# EASTWOOD VILLAGE

## PRE-DEVELOPMENT GRADING AND EROSION CONTROL PLANS

EASTWOOD VILLAGE  
EL PASO COUNTY, COLORADO  
GRADING AND EROSION CONTROL  
COVER SHEET

PROJECT NO.  
096726002  
SHEET  
**C4.0**

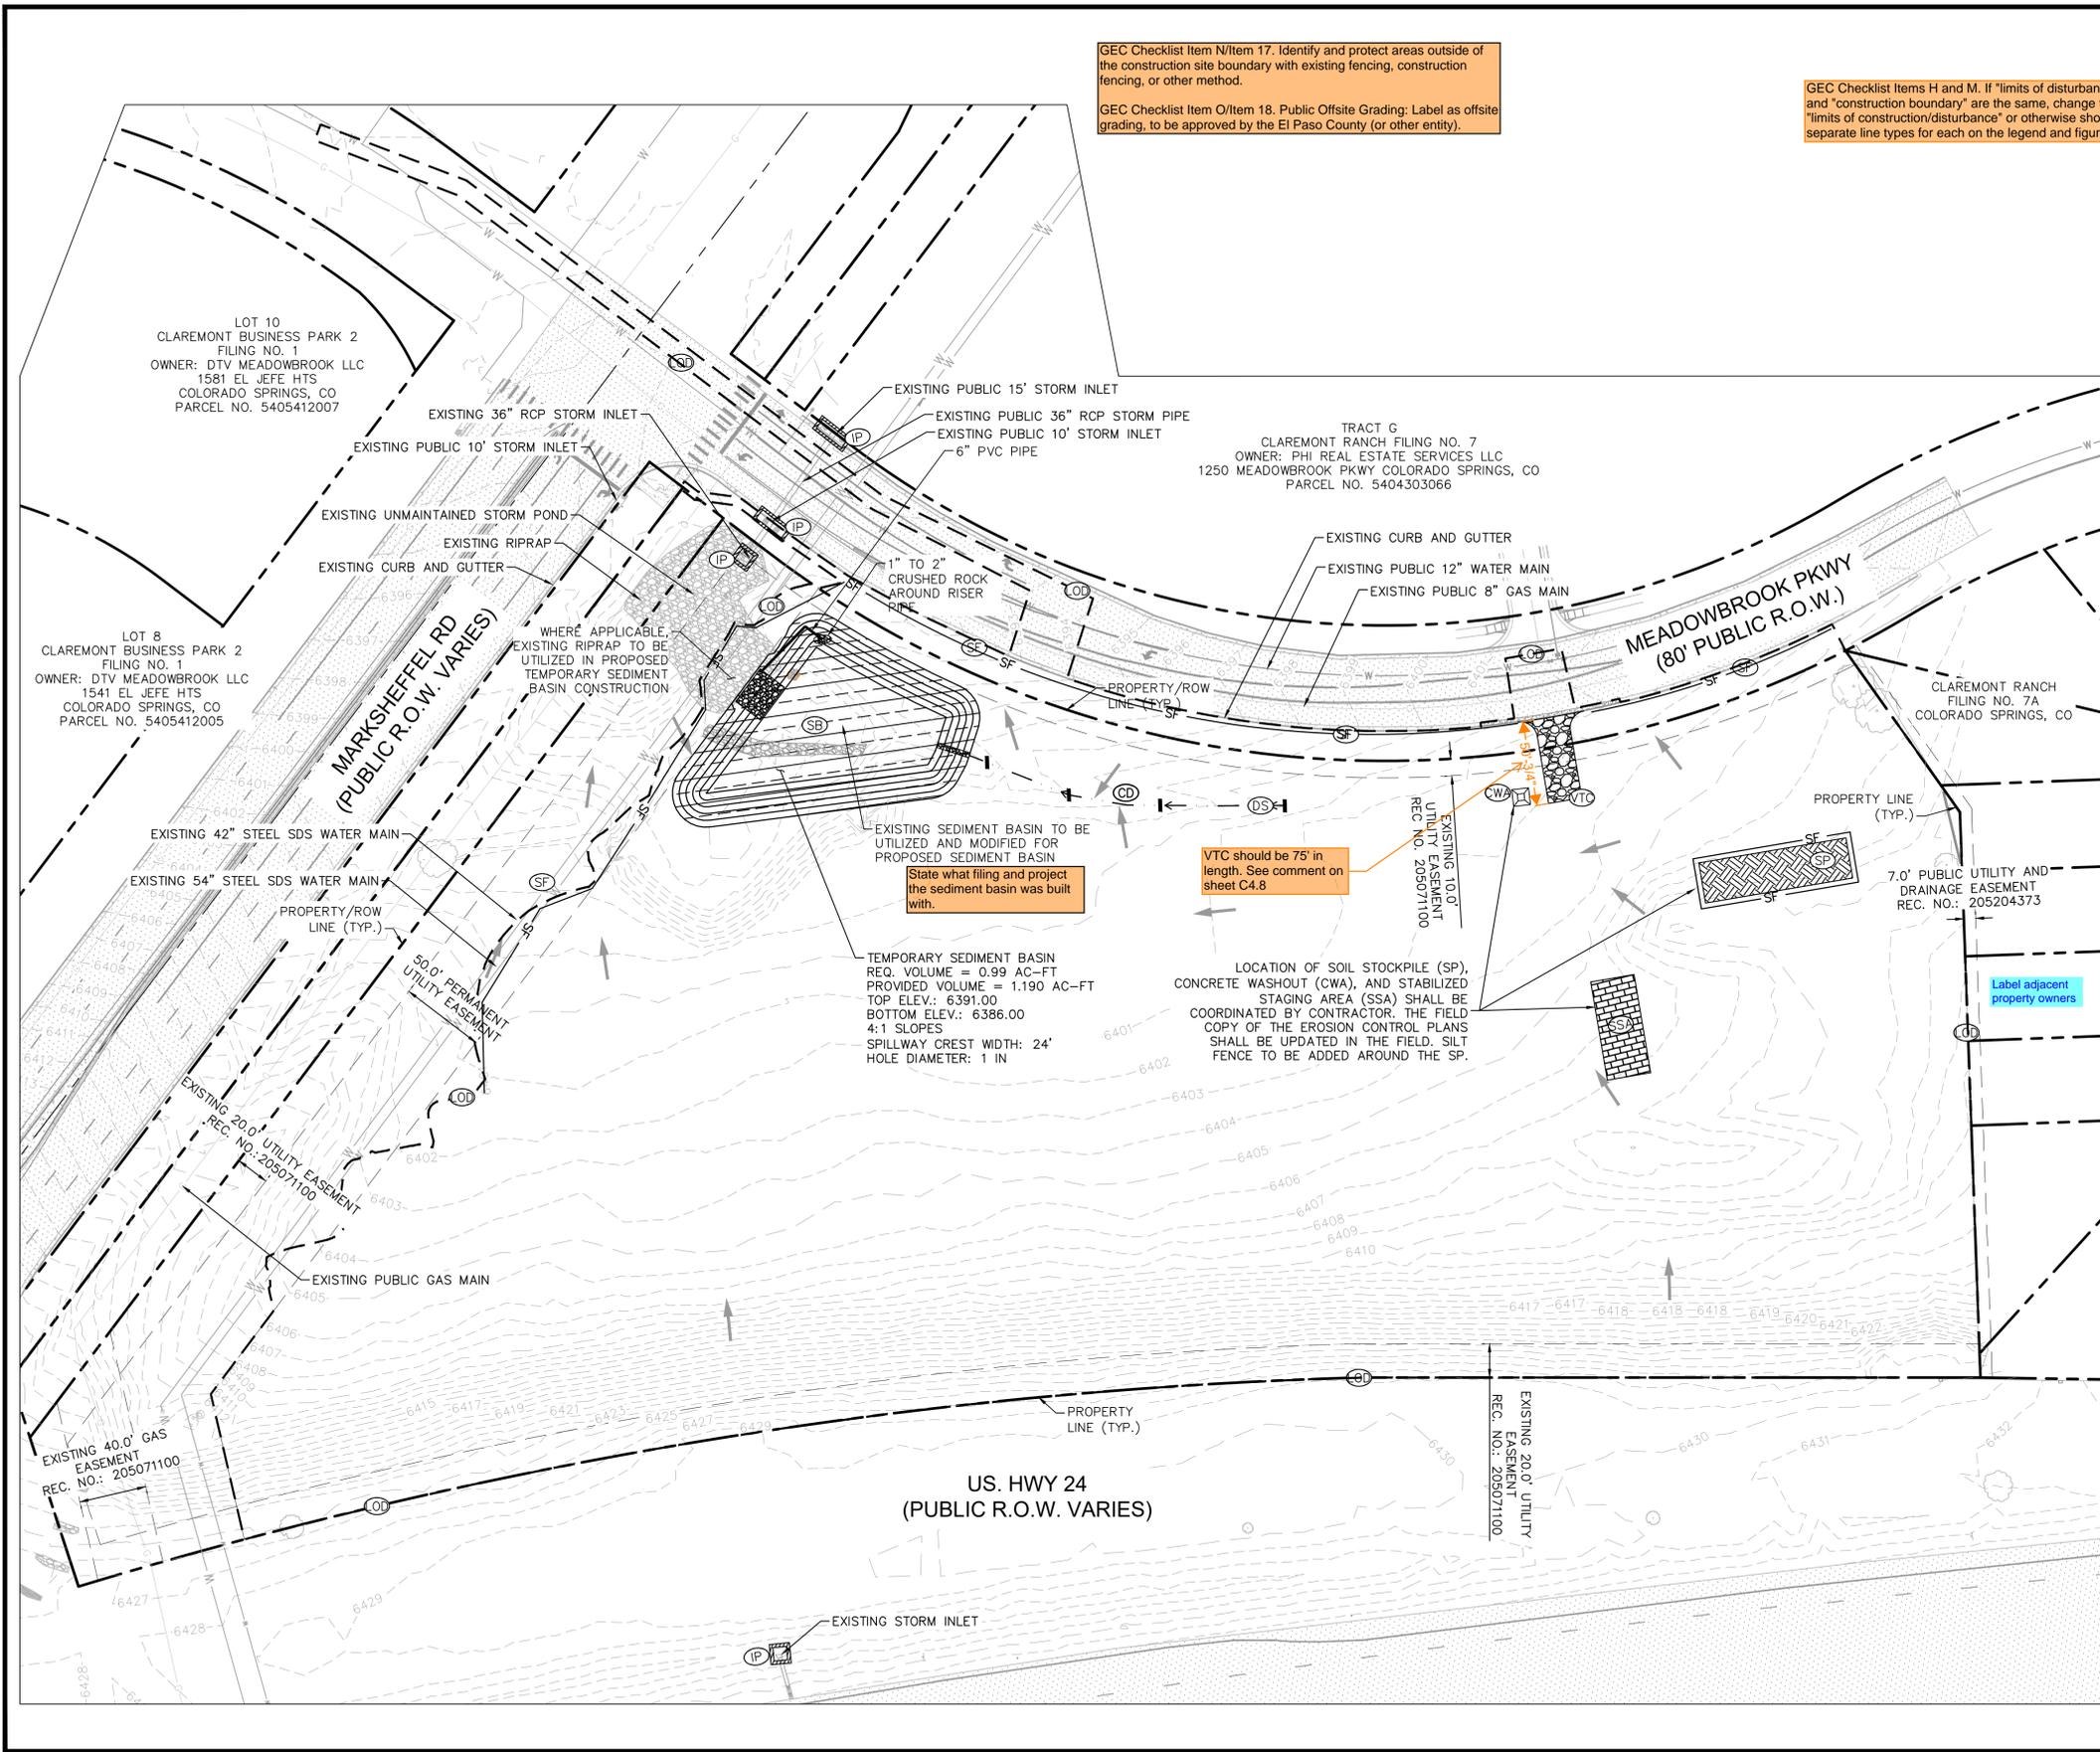
**BENCHMARK/ PROJECT CONTROL:**  
FIMS MONUMENT NUMBER 78 IS A BERNTSEN TOP SECURITY MONUMENT SYSTEM WITH A 3.25 INCH DIAMETER ALUMINUM FIMS CAP IN A ROAD BOX, LOCATED AT THE NORTHWEST CORNER OF U.S. HIGHWAY 24 AND MARKSHEFFEL ROAD. THE CORNER FENCE POST IS 28.3 FEET TO THE NORTHEAST AND A FIMS NAIL/WASHER IN A FENCE POST IS 34.7 FEET TO THE SOUTHWEST. ELEVATION = 6427.35 "1929 AND THE 1960 SUPPLEMENTARY ADJUSTMENT"  
**Provide the vertical and horizontal datums.**

PROJECT NO.  
 096726002  
 SHEET  
**C4.1**

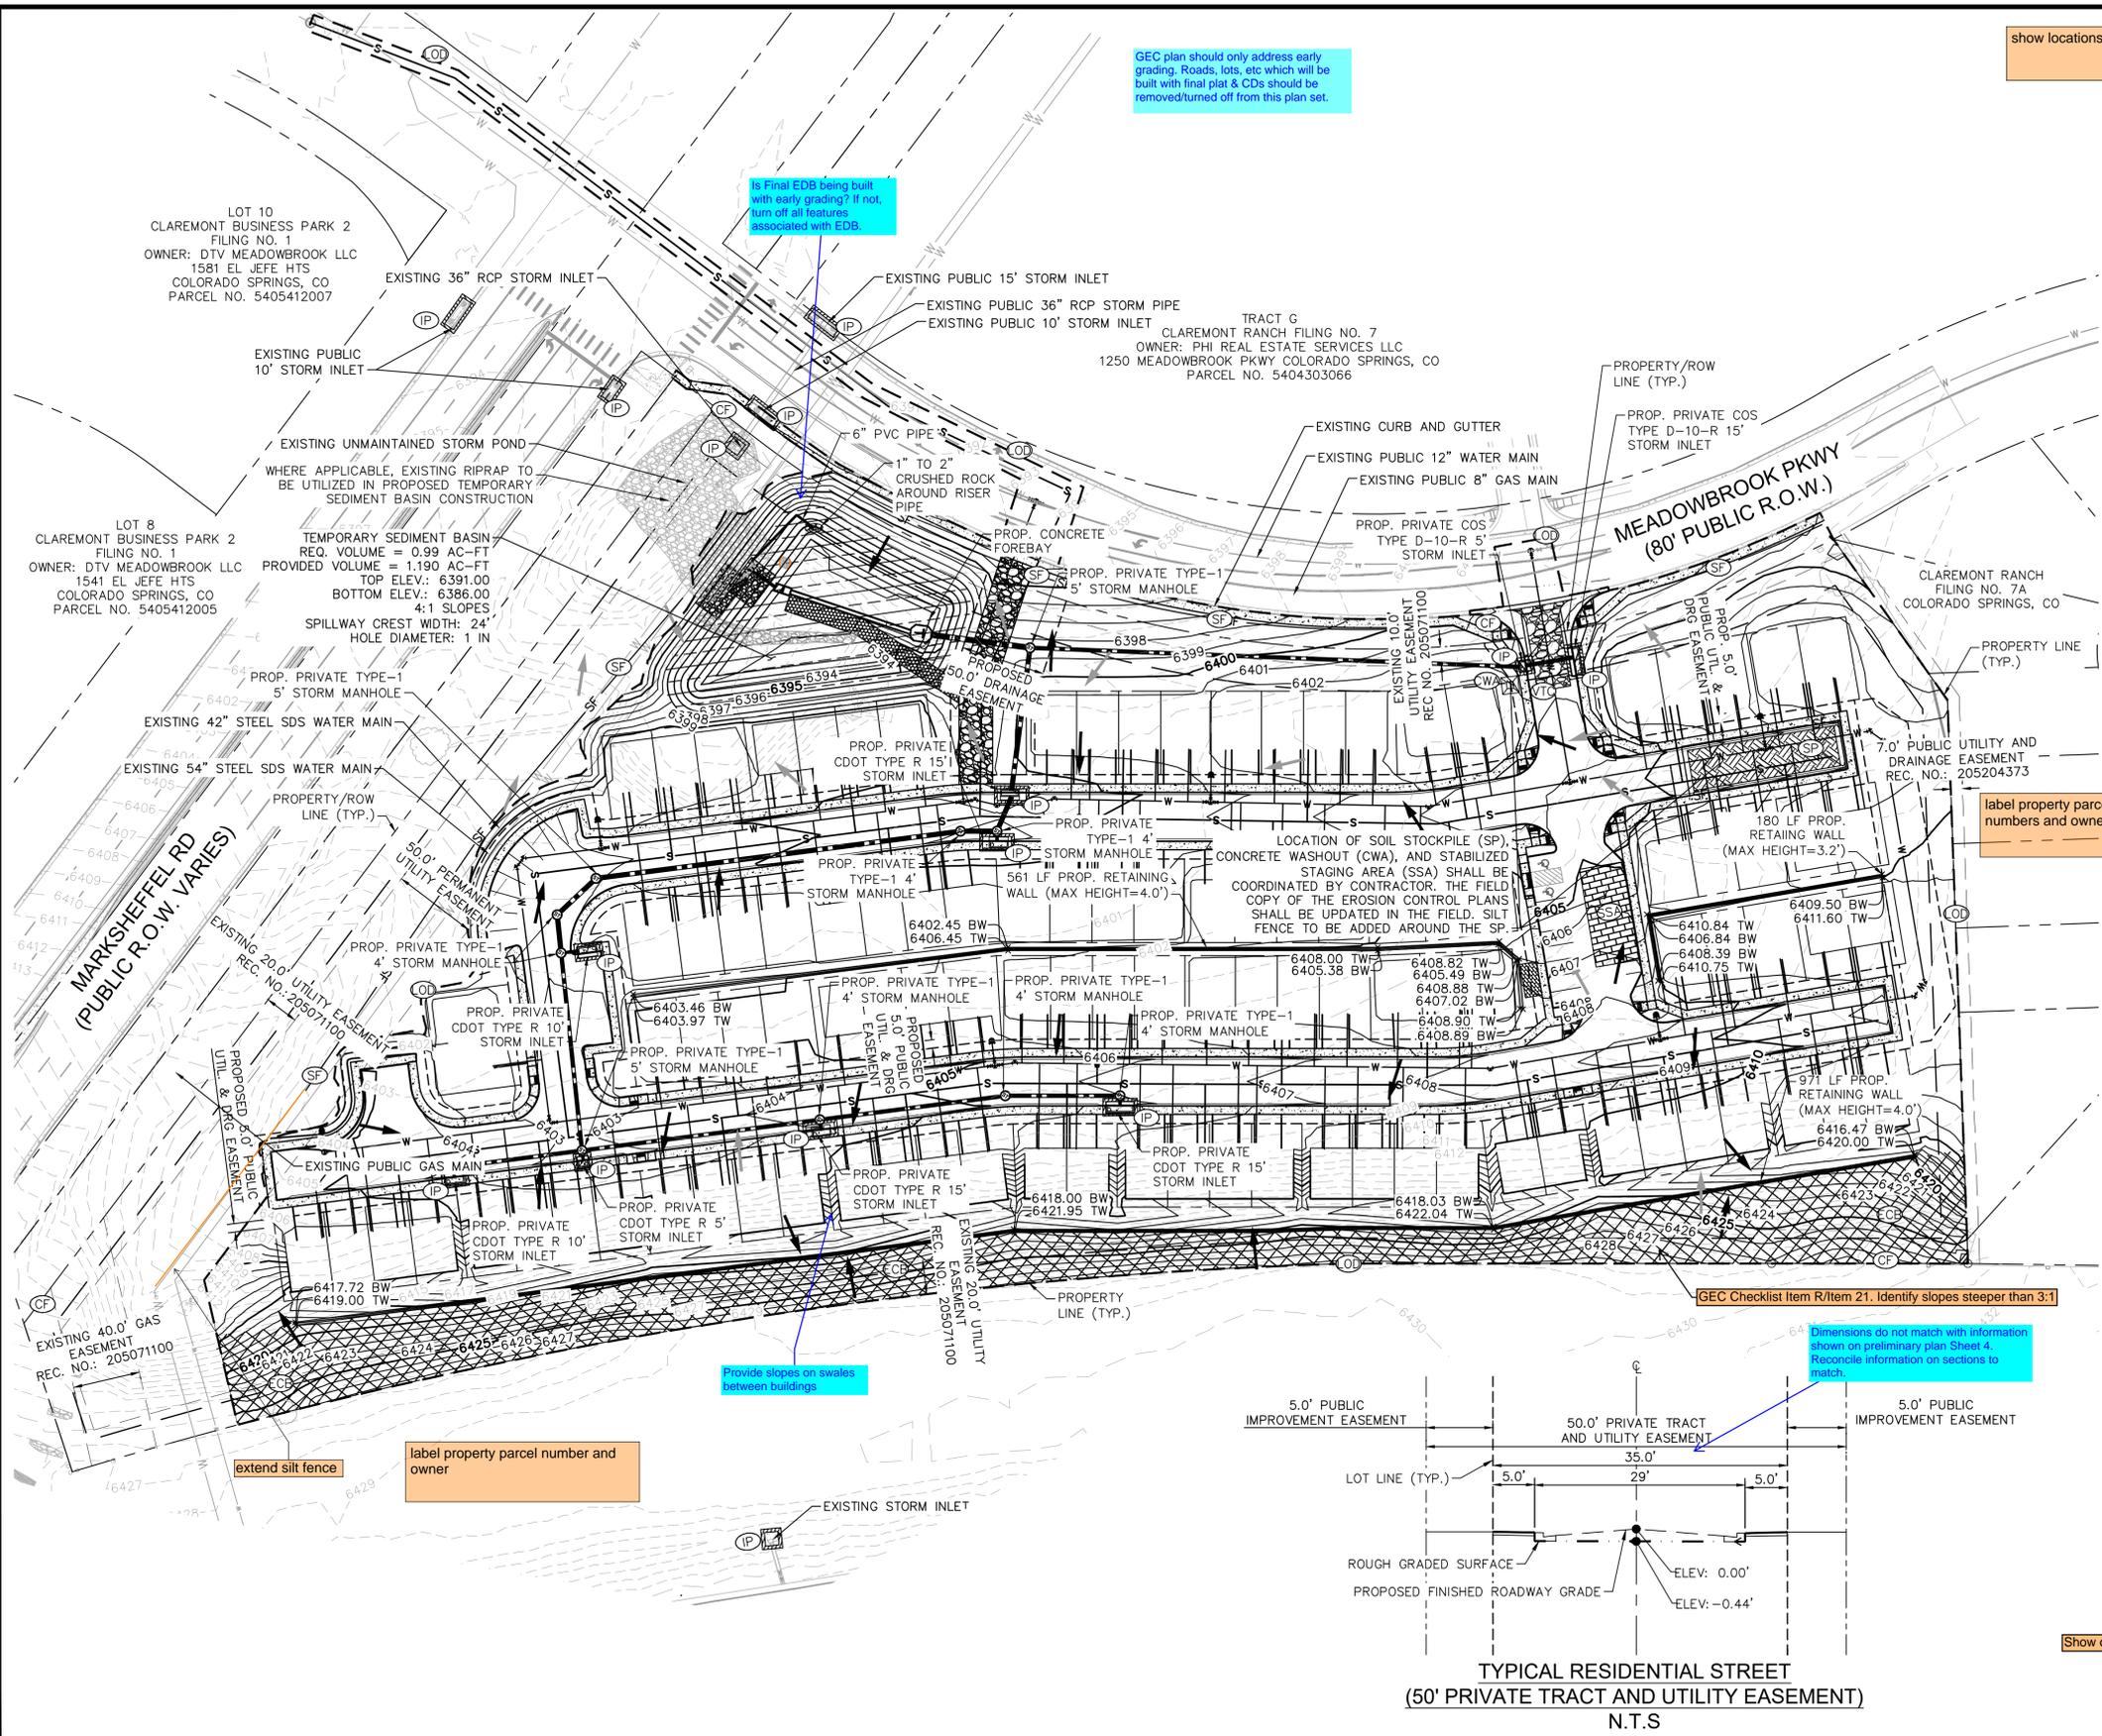
GEC Checklist Item N/Item 17. Identify and protect areas outside of the construction site boundary with existing fencing, construction fencing, or other method.  
 GEC Checklist Item O/Item 18. Public Offsite Grading: Label as offsite grading, to be approved by the El Paso County (or other entity).

GEC Checklist Items H and M. If "limits of disturbance" and "construction boundary" are the same, change to "limits of construction/disturbance" or otherwise show as separate line types for each on the legend and figure.

GEC Checklist Item O (on updated checklist)/Item 11. Public Offsite Grading: Label as offsite grading, to be approved by the El Paso County (or other entity).

- IN EXISTING CONDITIONS, THE SITE IS UNDEVELOPED WITH LITTLE TO NO VEGETATION. REFERENCE GEOTECH FOR ADDITIONAL INFORMATION ON EXISTING VEGETATION AND SOIL CONDITIONS.
  - SITE IS IN ZONE X (OUTSIDE OF FEMA FLOODPLAIN).
  - STREET SWEEPING IS REQUIRED ALONG MEADOWBROOK PARKWAY AT LEAST ONCE A DAY BY HAND OR USE OF A STREET SWEEPER.
- To comply with the SWMP Checklist Item 17f, please add a note stating no batch plants will be utilized onsite.

SHEET  
C4.2

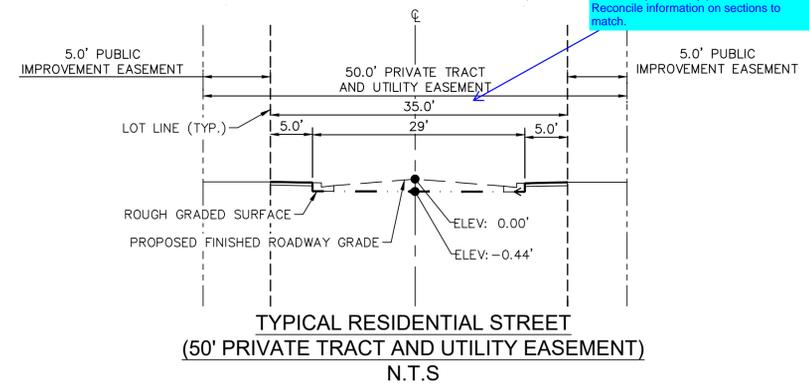
show locations of interim seeding/mulching

GEC plan should only address early grading. Roads, lots, etc which will be built with final plat & CDs should be removed/turned off from this plan set.

Is Final EDB being built with early grading? If not, turn off all features associated with EDB.

label property parcel numbers and owners

label property parcel number and owner

Provide slopes on swales between buildings

Dimensions do not match with information shown on preliminary plan Sheet 4. Reconcile information on sections to match.

Show on plans

**Earth Dikes and Drainage Swales (ED/DS) EC-10**

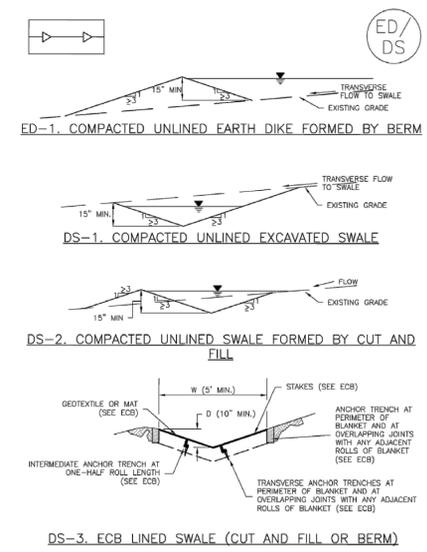
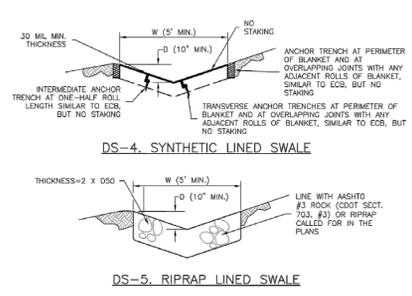
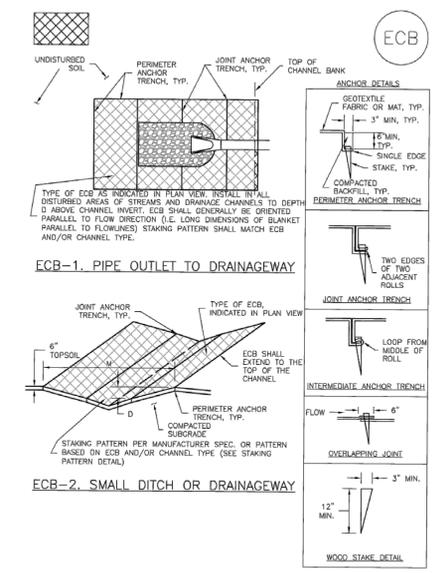
Indicate on plans where these are and include in legend
